NSUR - Control Board

TITLE: NS_ARM_Control_07_17_2017

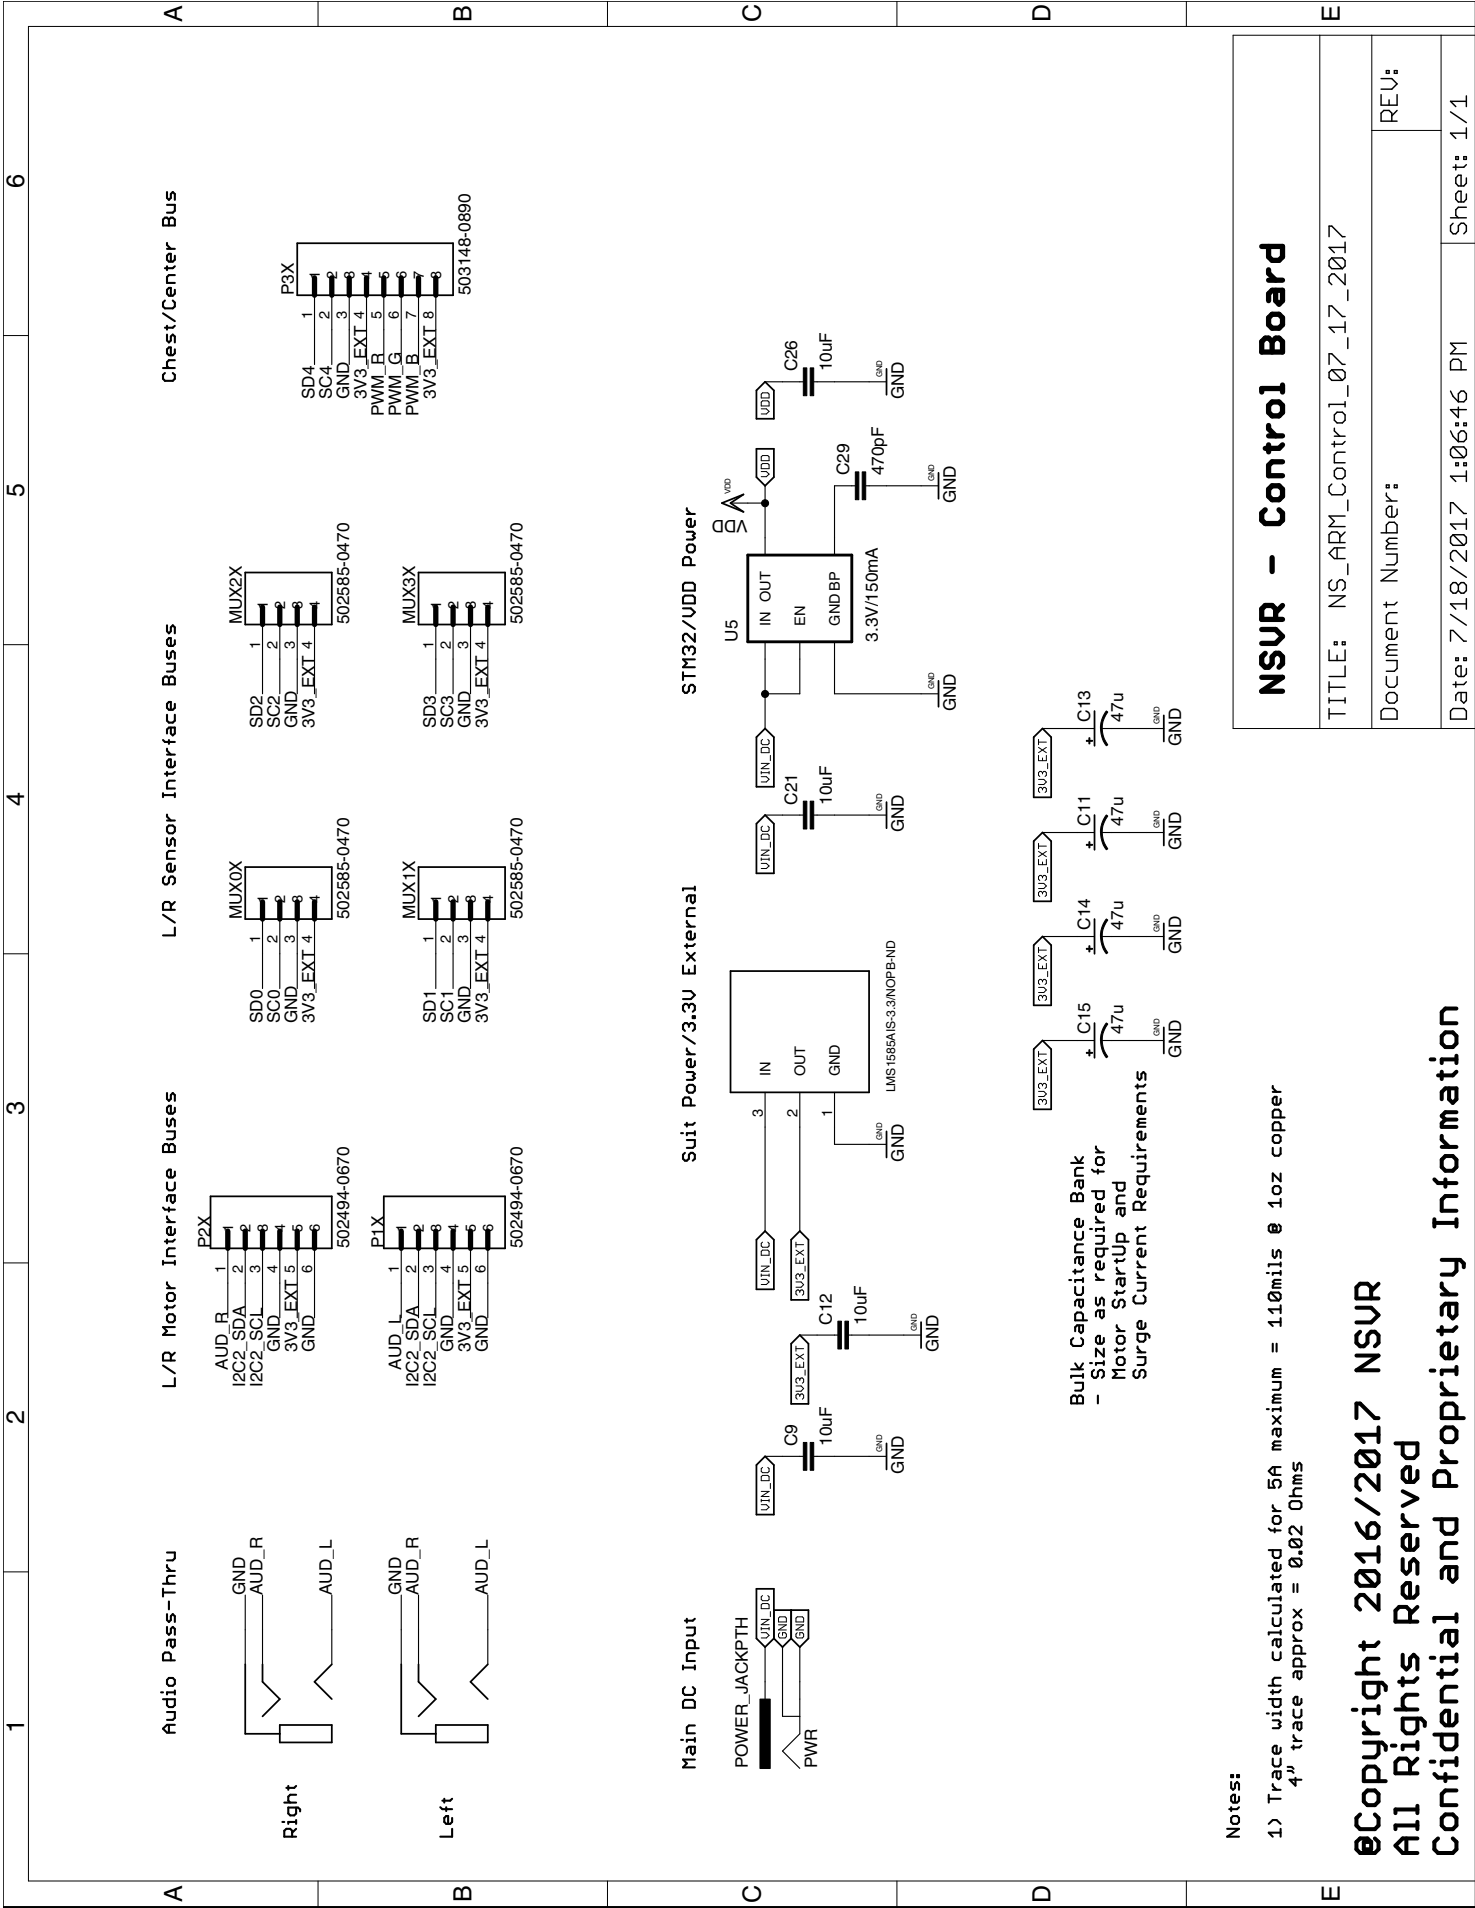
NOTE :
There are no pullup resistors on the downstream hub lines---
You are depending on having them on the downstream devices!
